APPEAL SUMMARY

Appeal ID: 20544	Project Address: 350 SW Jefferson St
Hearing Date: 6/19/19	Appellant Name: John Heinen
Case No.: B-015	Appellant Phone: 5034457372
Appeal Type: Building	Plans Examiner/Inspector: John Cooley
Project Type: commercial	Stories: 6 Occupancy: B Construction Type: 1-A
Building/Business Name: Wells Fargo Center	Fire Sprinklers: Yes - Throughout building
Appeal Involves: Alteration of an existing structure LUR or Permit Application No.: 18-208035-CO	
Plan Submitted Option: pdf [File 1]	Proposed use: Office Building

WELLS FARGO CENTER RENOVATION - EXCHANGE BLOCK

7 CURTAIN WALL AT EXISTING COLUMN - RATED
1 1/2\"/>

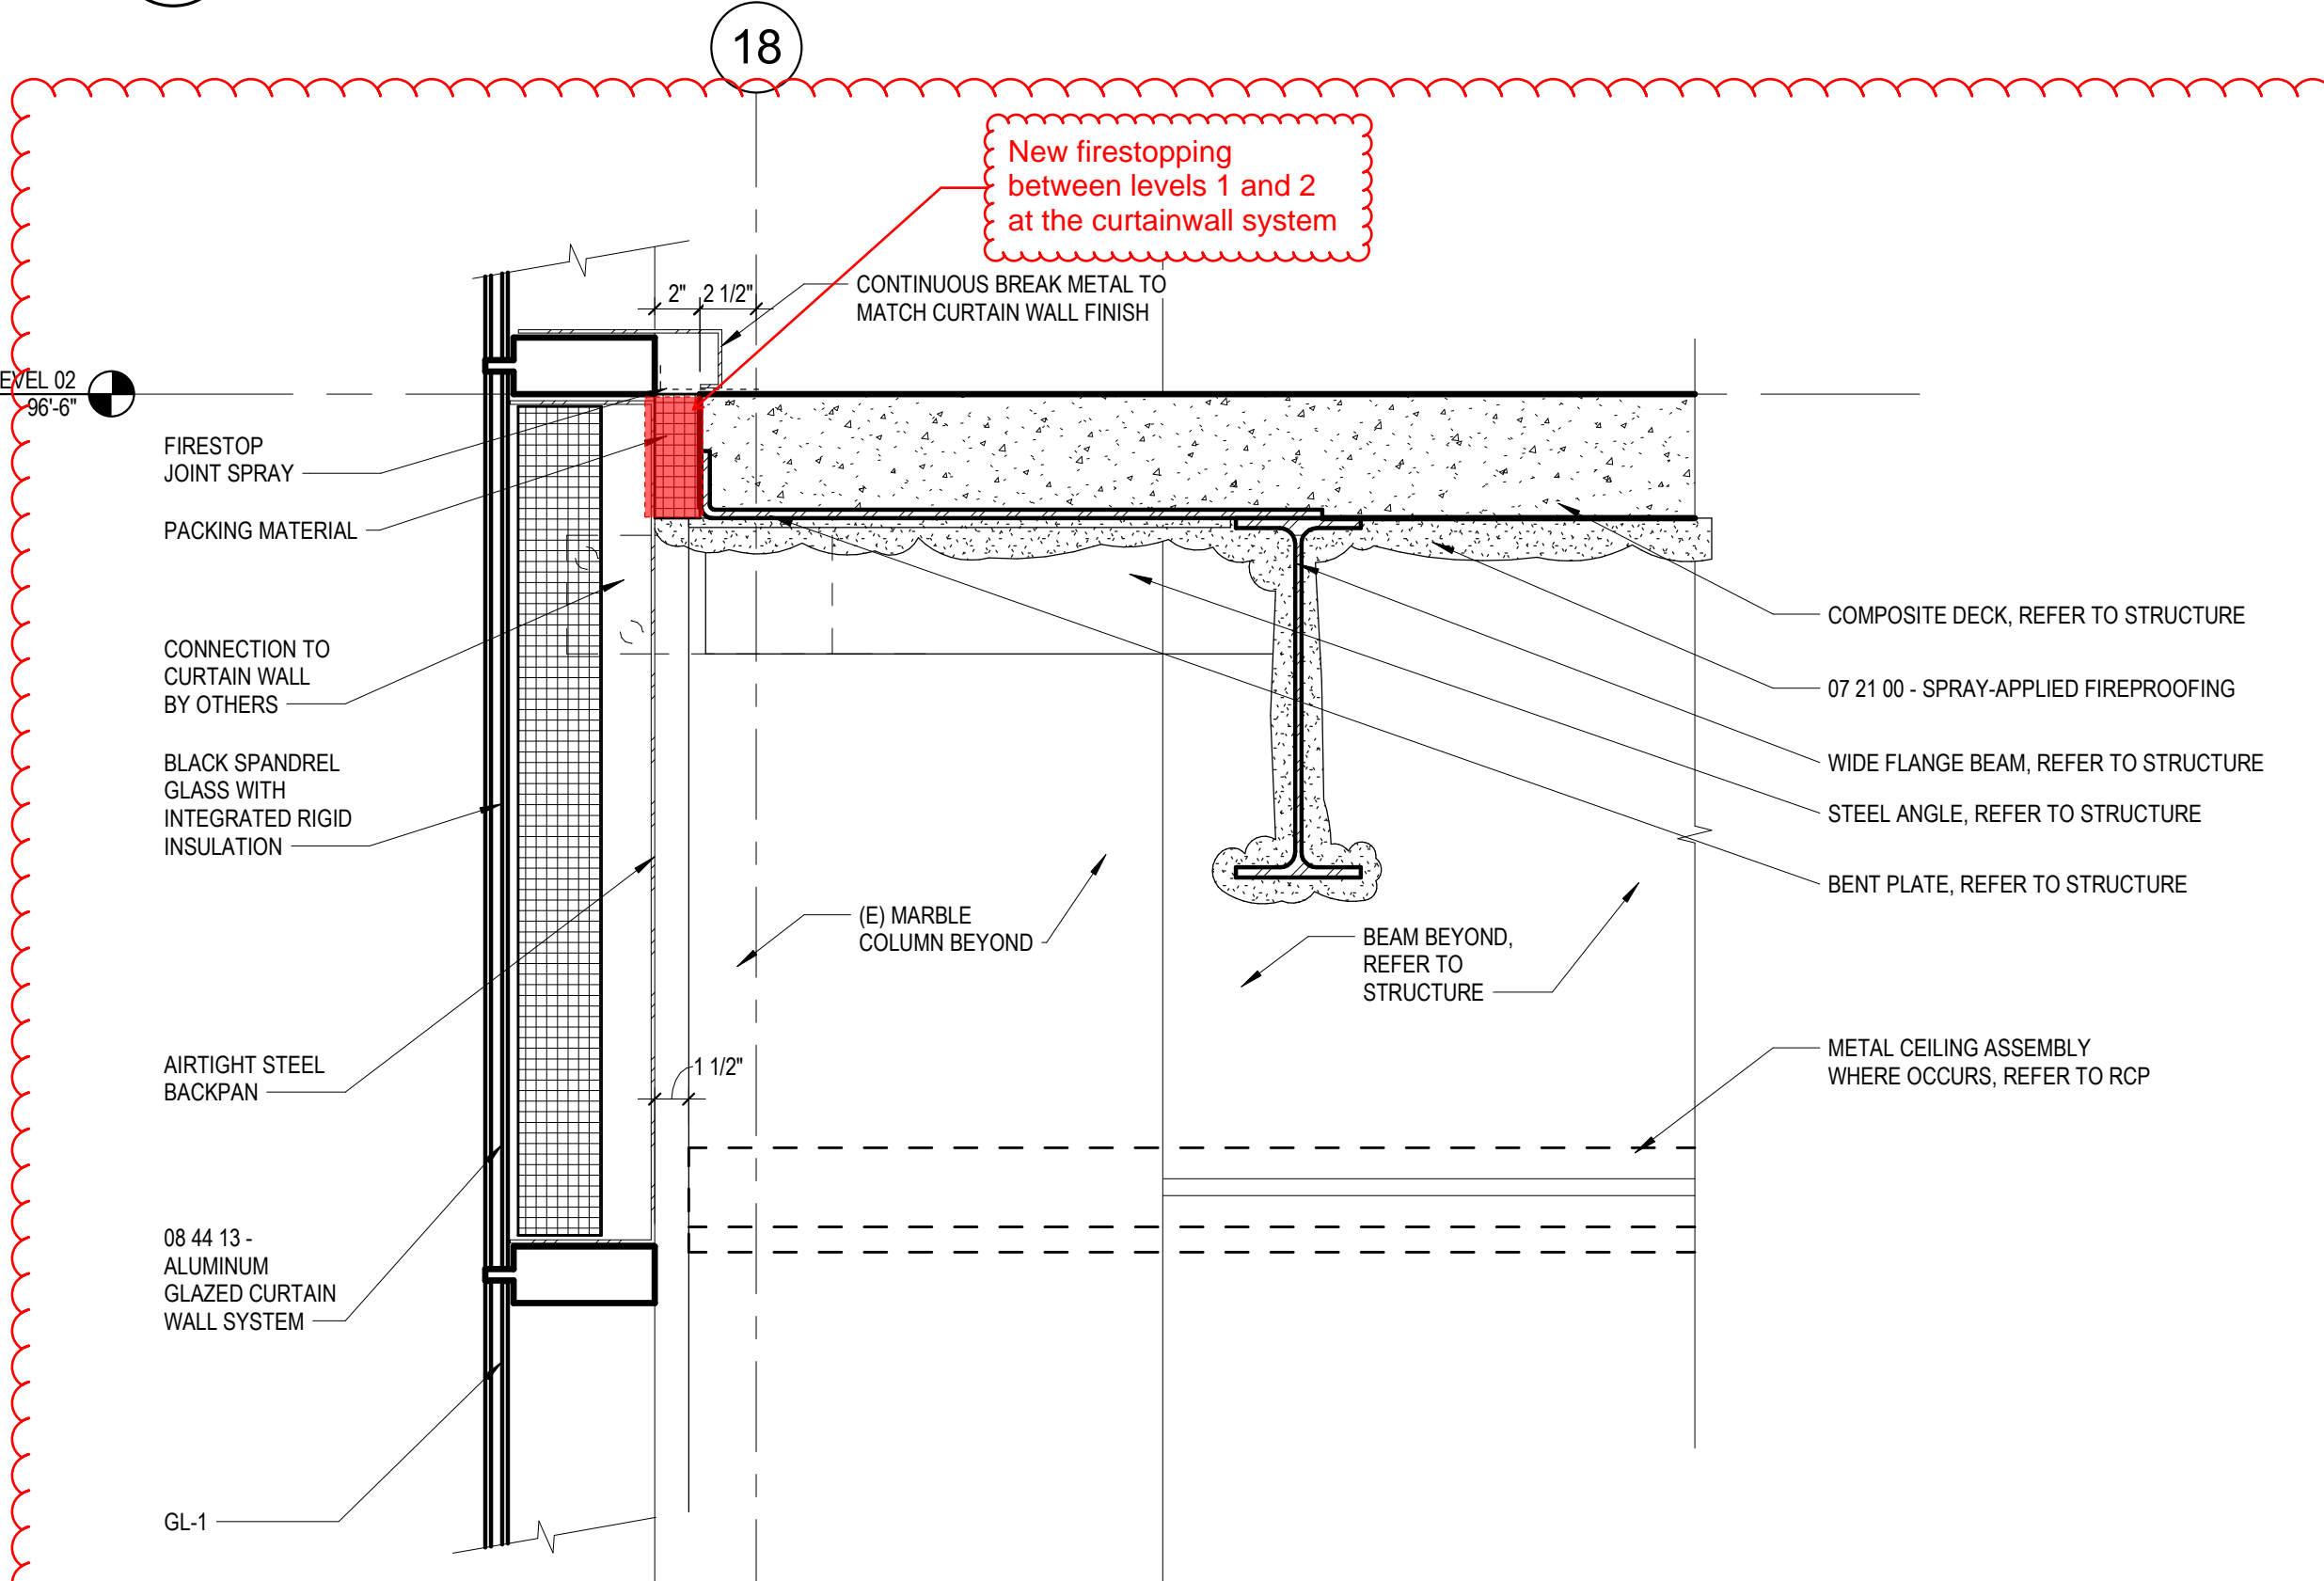
Reason for alternative Providing a vertical 2-hour fire rated assembly at the columns per detail 7/A701 is an acceptable alternative to providing a horizontal 2-hour fire rated assembly extension of the floor from the new concrete deck to the existing stone column surrounds for the following reasons;

- The materials comprising the existing stone veneer column wraps, stone, fireproofing, steel channels and steel column, are non-combustible. The new proposed design does not add combustible materials to the existing column surrounds.

- Levels 1 and 2 are effectively separated from each other at the columns by a 2-hour rated vertical assembly that has the same rating as the 2-hour rated horizontal floor assembly noted in Table 601. The assembly is continuous between the 2-hour rated concrete floors on levels 1 and 2.

Non-continuous 2 hour fire rated floor assembly: Granted as proposed.

The Administrative Appeal Board finds that the information submitted by the appellant demonstrates that the approved modifications or alternate methods are consistent with the intent of the code; do not lessen health, safety, accessibility, life, fire safety or structural requirements; and that special conditions unique to this project make strict application of those code sections impractical.

2 CURTAIN WALL AT LEVEL 2
1 1/2\"/>

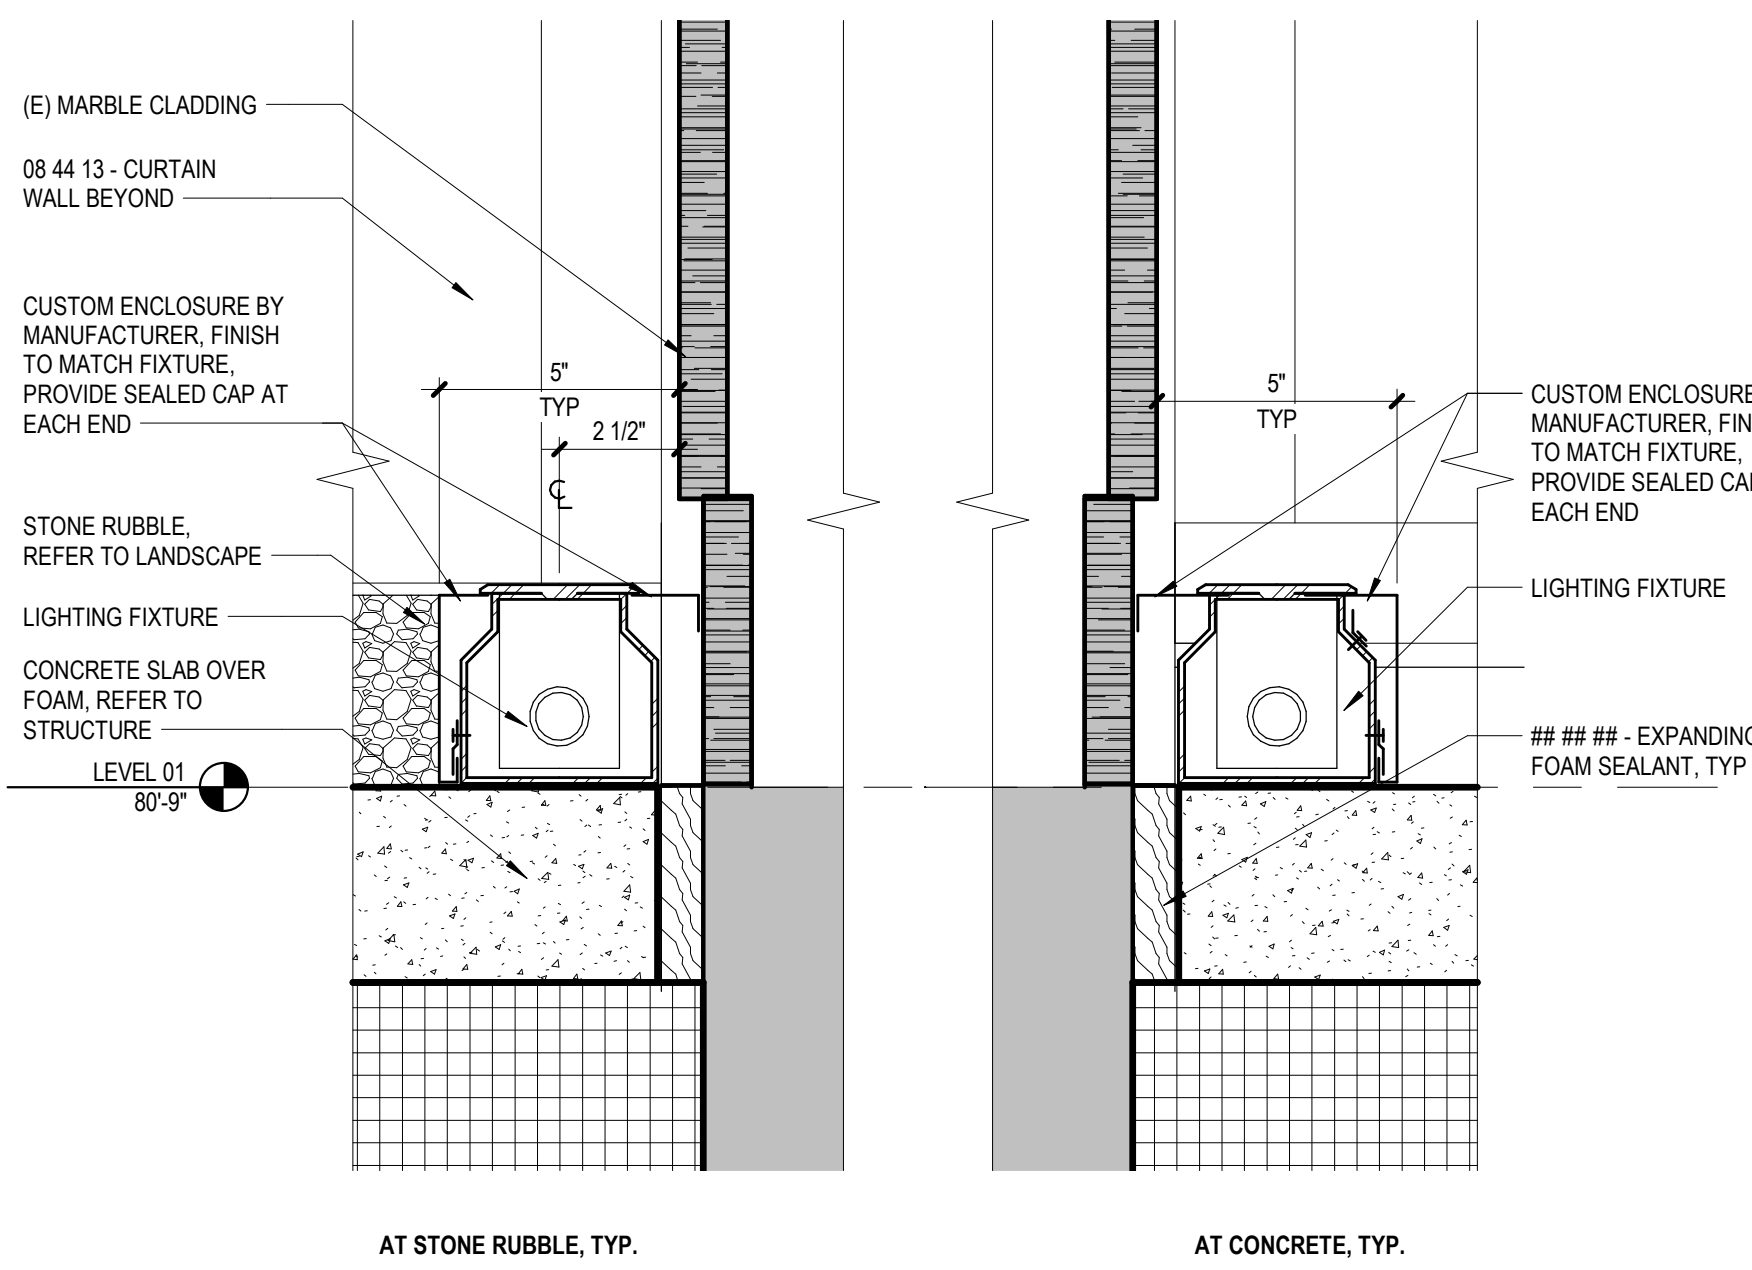
- The separation continues along the 2-hour rated concrete floors to the new curtainwall which has a 2-hour rated firestopping assembly per detail 2/A701.
